ADDENDUM NO.: 4

PROJECT NAME: **POLICE TRAINING ACADEMY HVAC COMPONENT REPLACEMENT**

DATE: 7/15/2013

CIMS PROJECT NO.: **35-06010**

ENLARGED MECHANICAL FLOOR PLAN - 2ND FLOOR, AREA-B

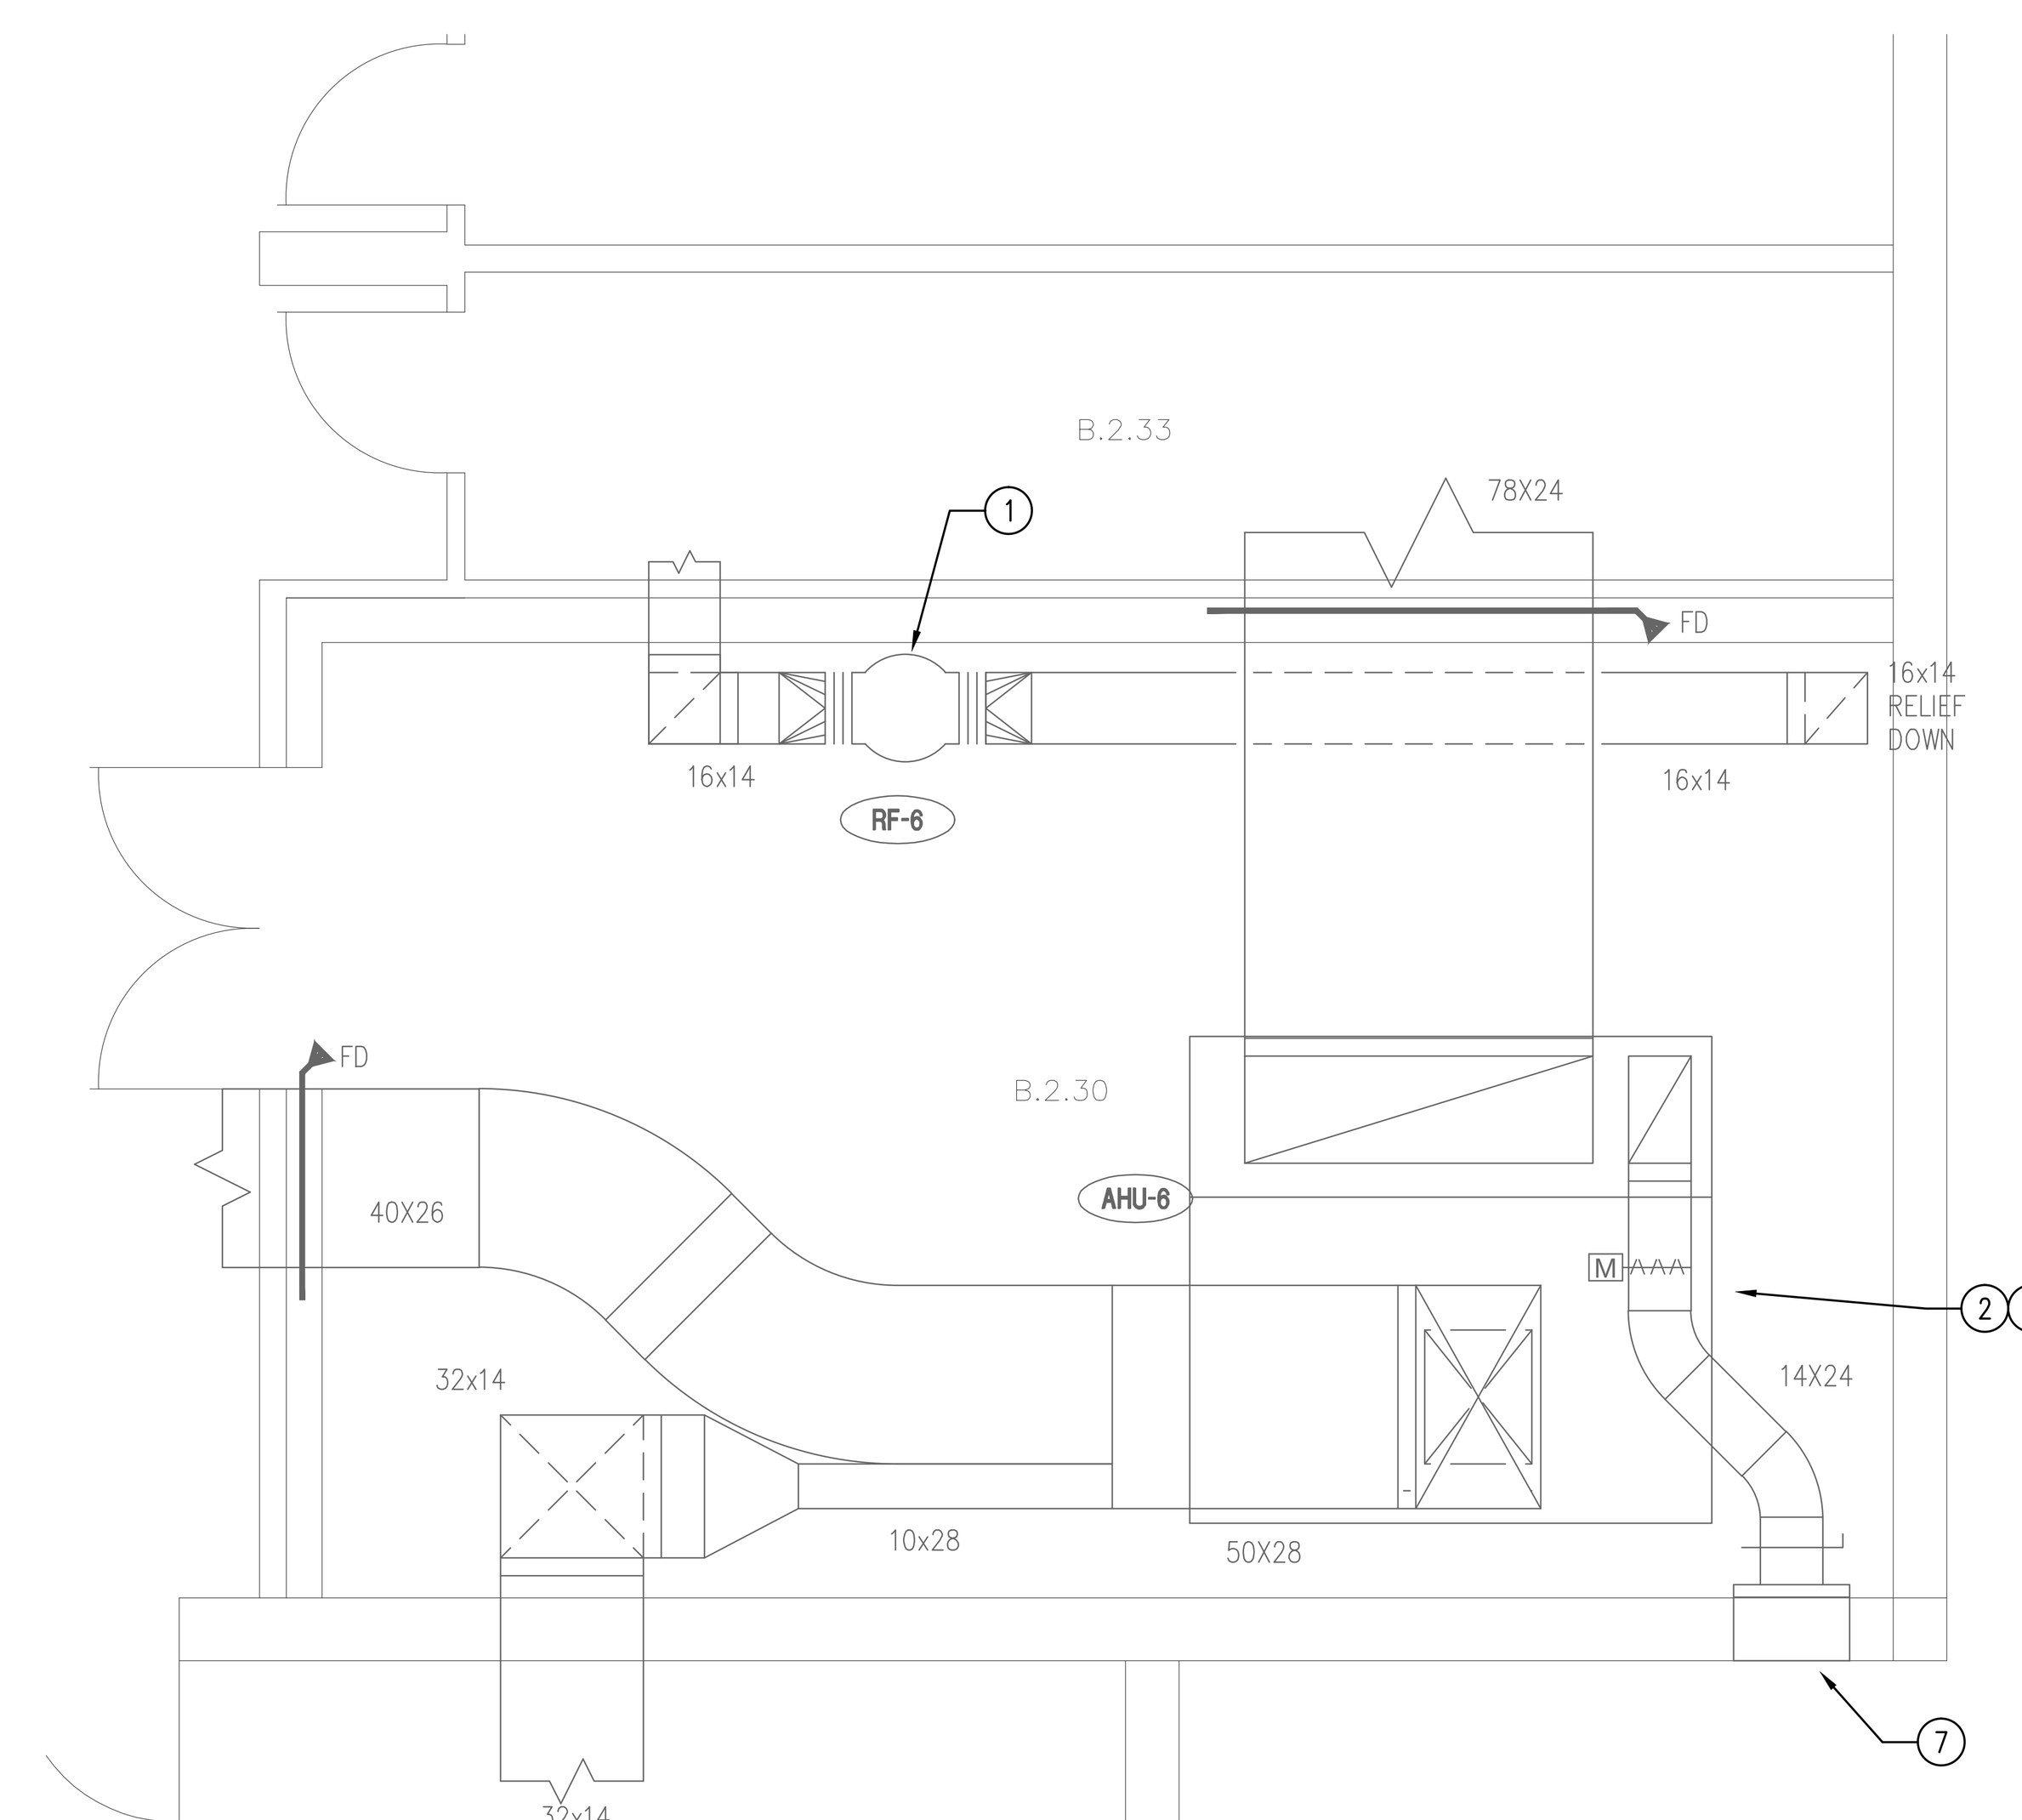
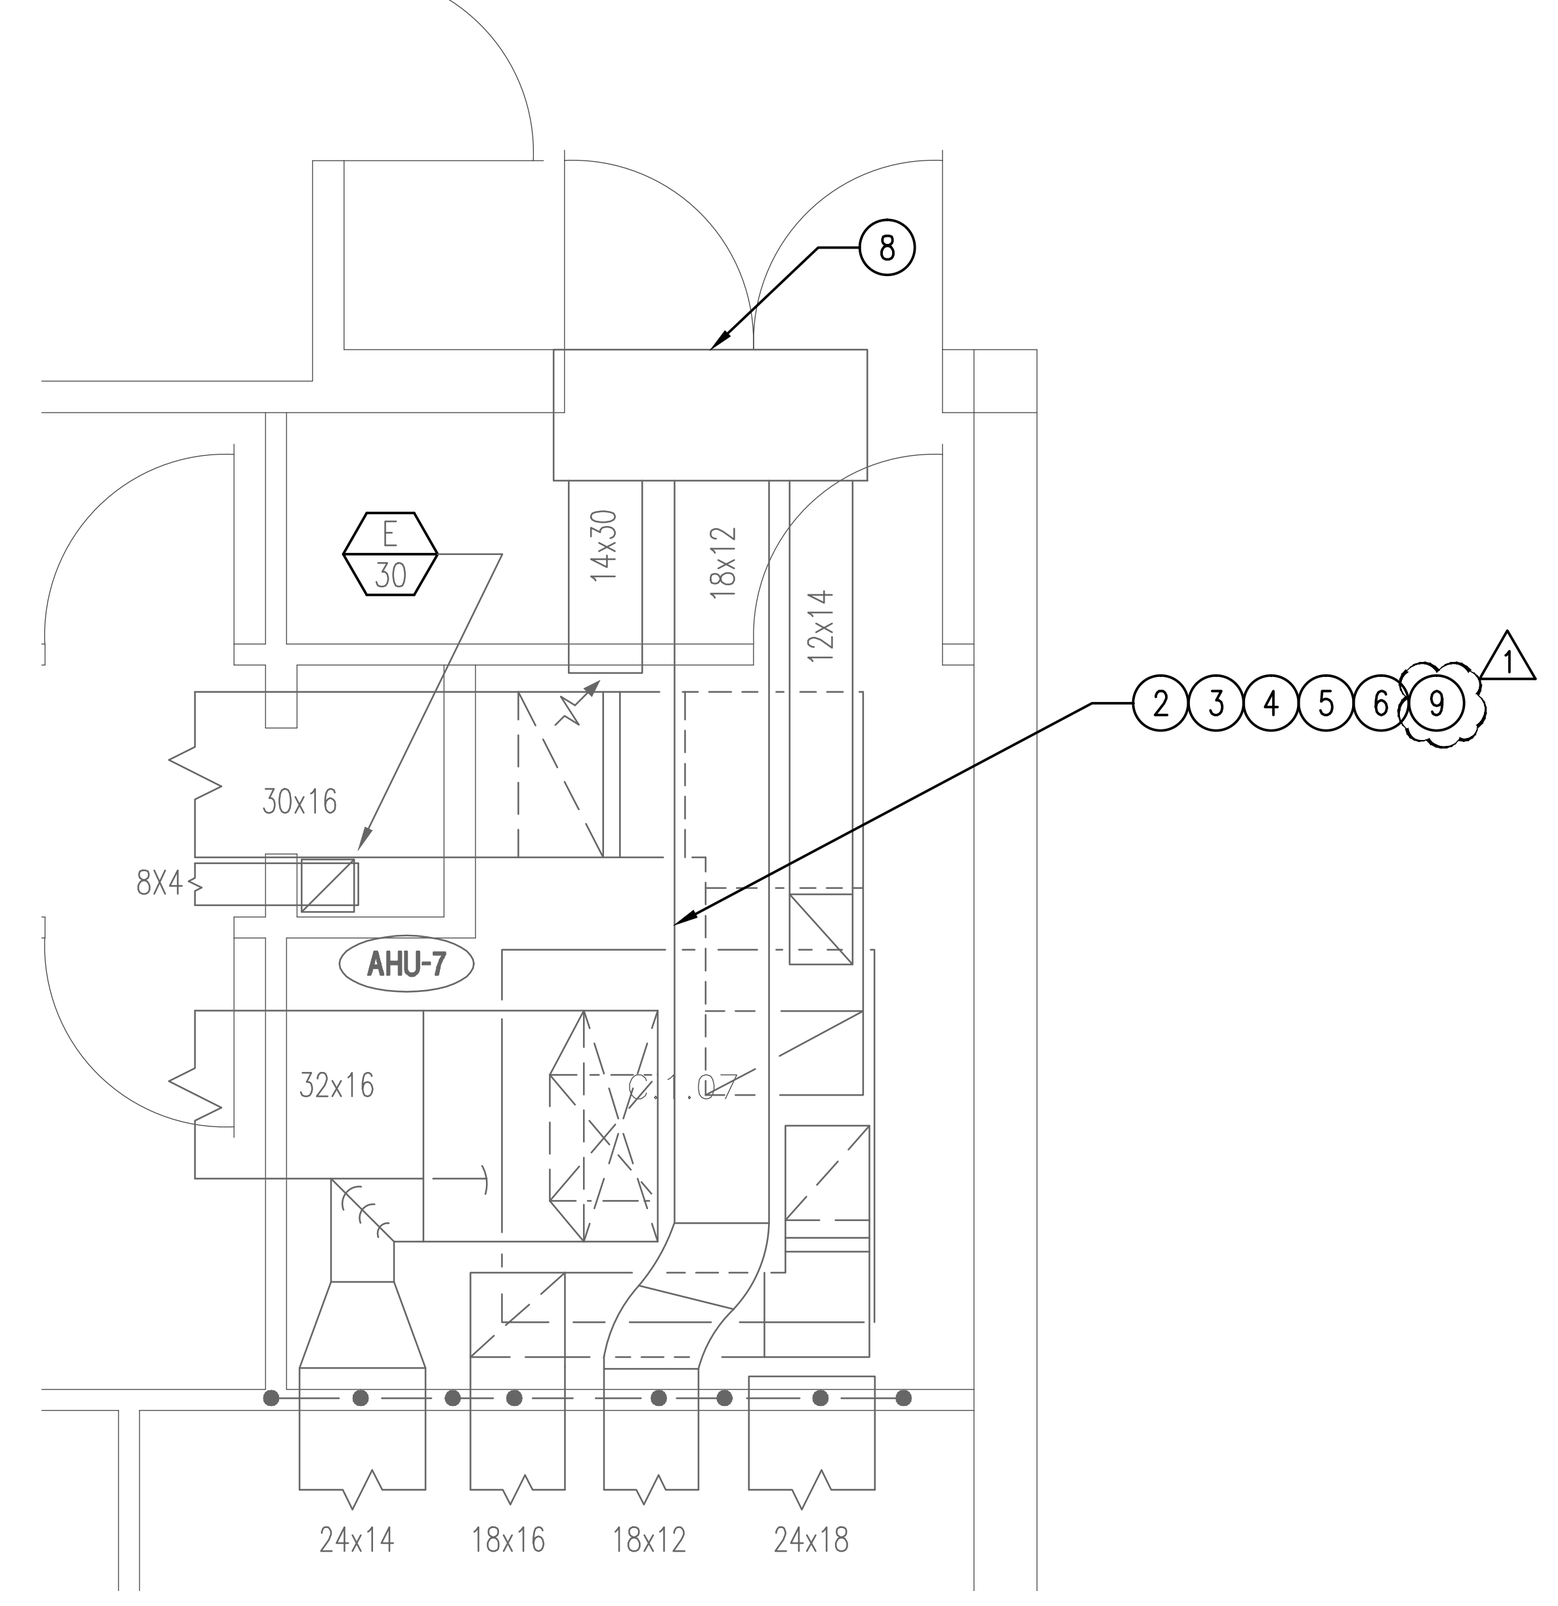
PLAN SHEET MD1.1

- Existing air handling units are to remain. Their respective coils, fan motors, condensate drain pans and piping and internal casing insulation is to be replaced with new.

SHEET
MD1.2
OF:

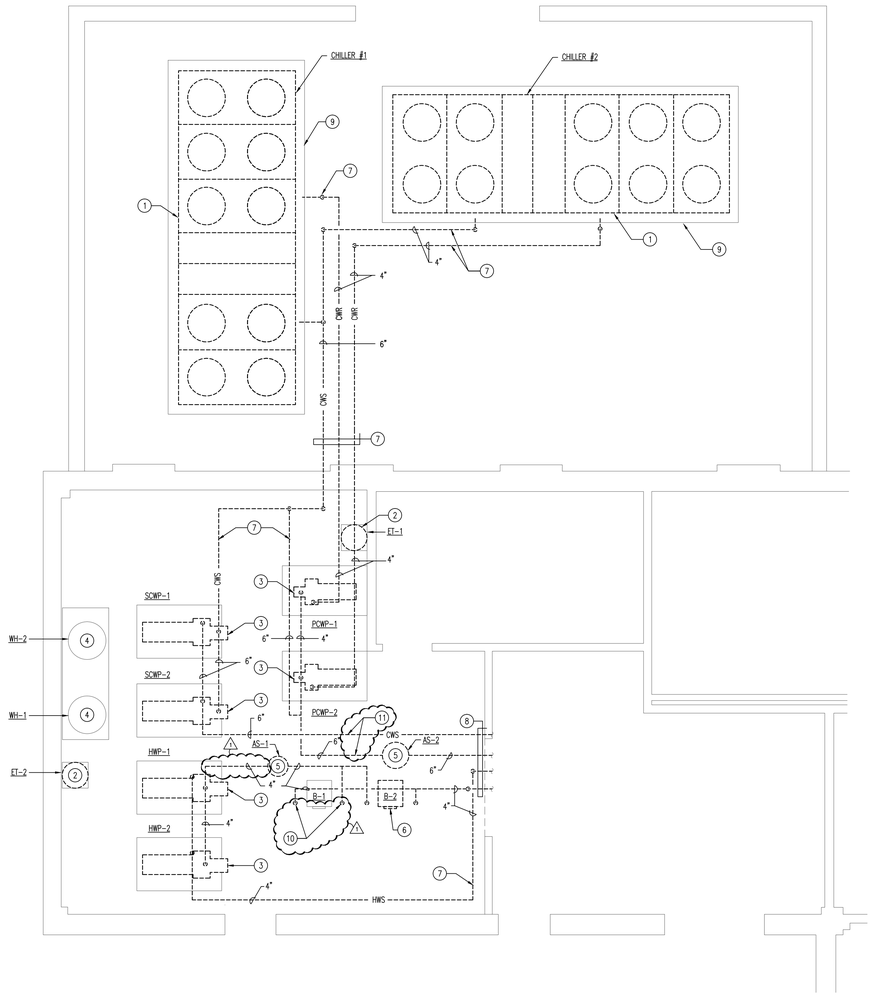
PLAN SHEET MD1.2

- A small portion of the hot water piping connection to one of the boilers is to remain.
- A small portion of the chilled water piping downstream of the emergency valved taps is to remain.

SHEET
M1.6
OF:

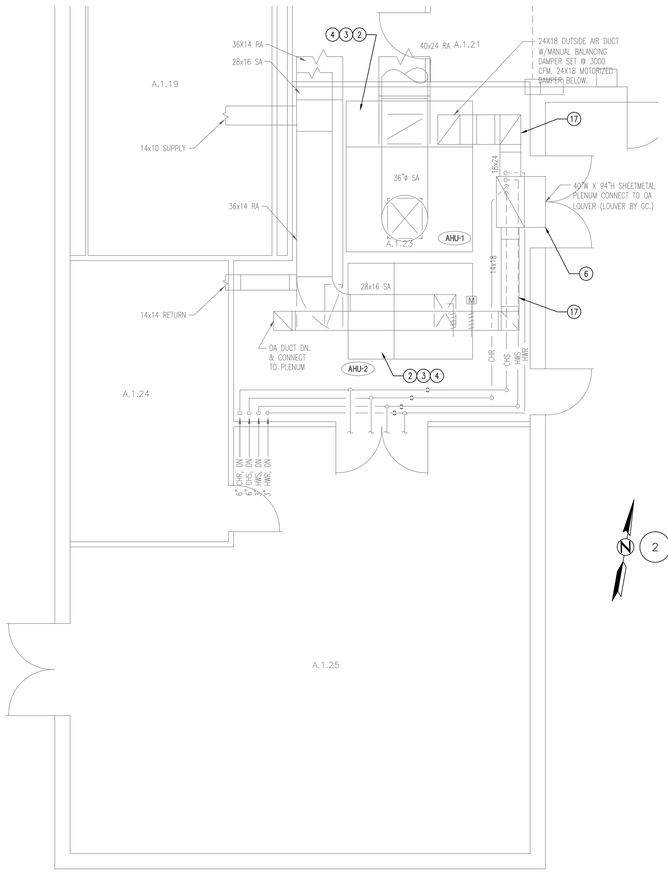
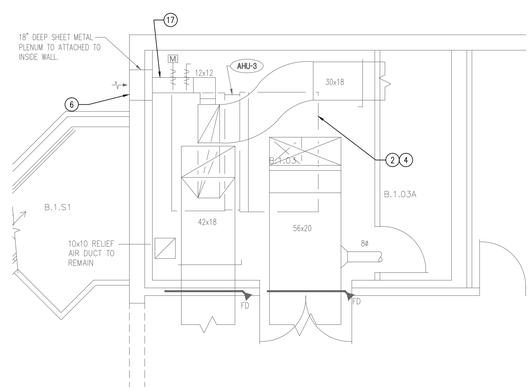
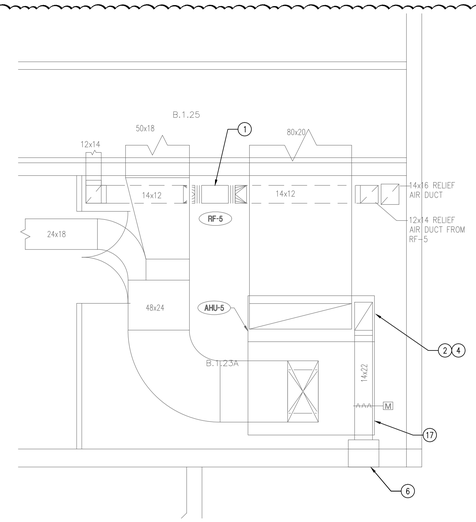
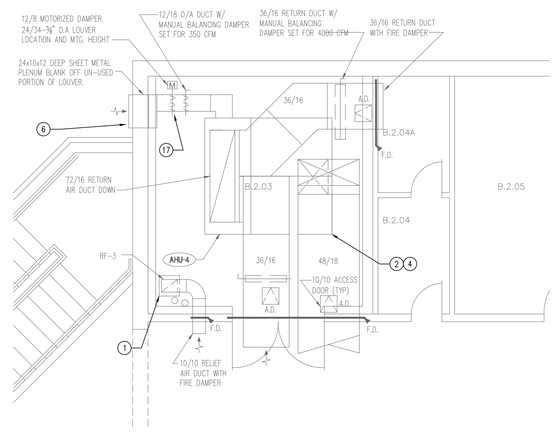
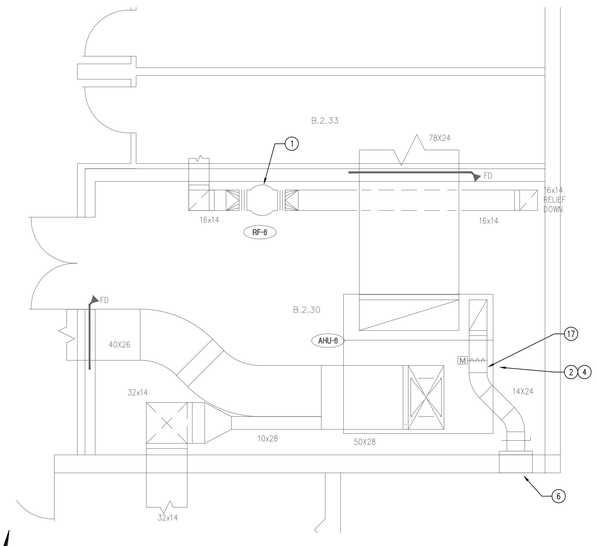
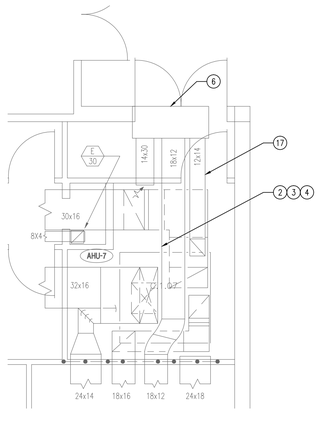
PLAN SHEET M1.6

- Existing air handling units are to remain. Their respective coils, fan motors, condensate drain pan and piping and internal casing insulation is to be replaced with new.

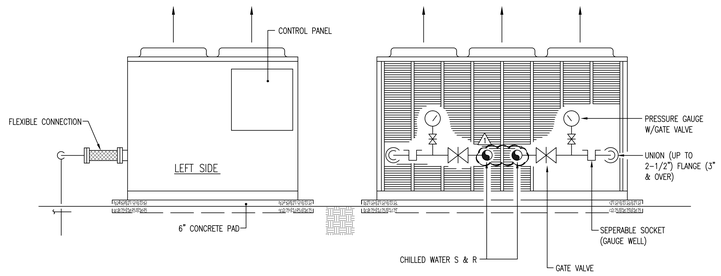
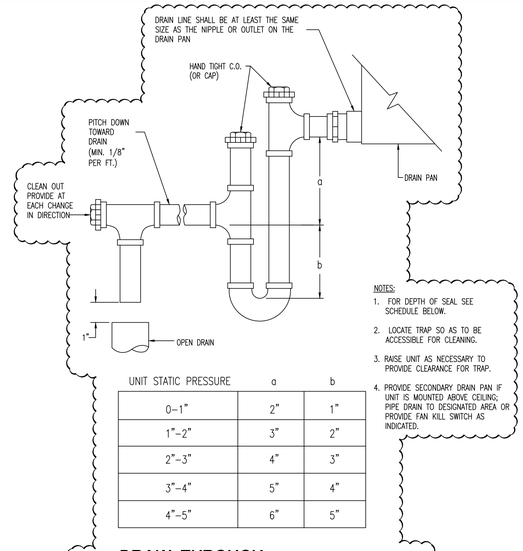
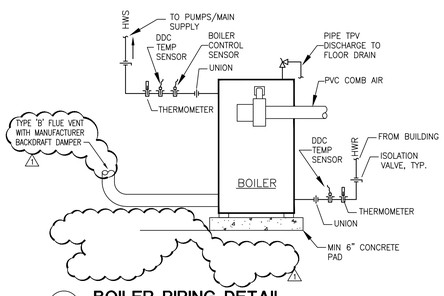
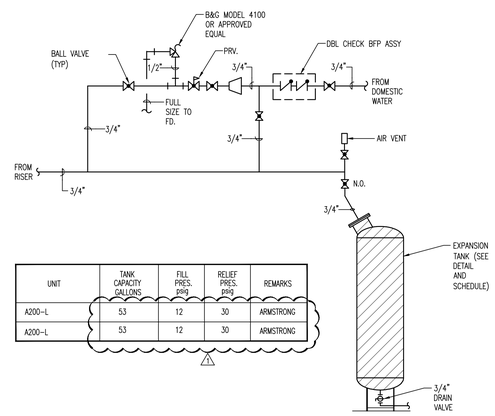
PLAN SHEET M4.1

- Revise Detail No.'s 2, 3, 4 and 5.
- Delete Detail No.'s 6 and 4/M6.0.

SHEET
M4.2
OF:

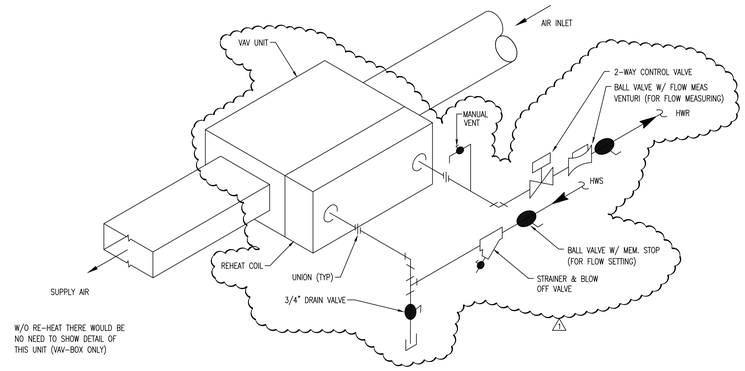
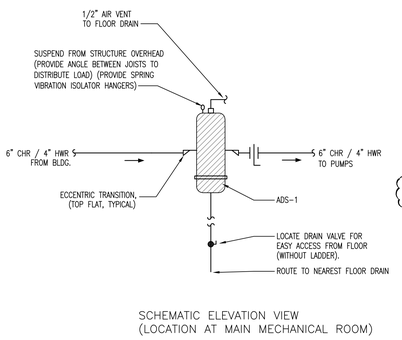
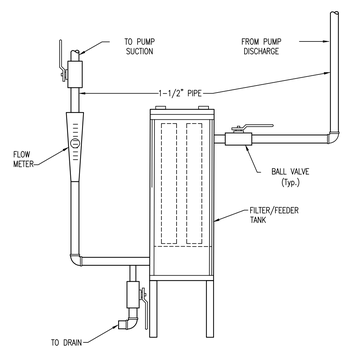
PLAN SHEET M4.2

- Revise Detail No.'s 3 and 4.
- Delete Detail No.'s 2 and 6.
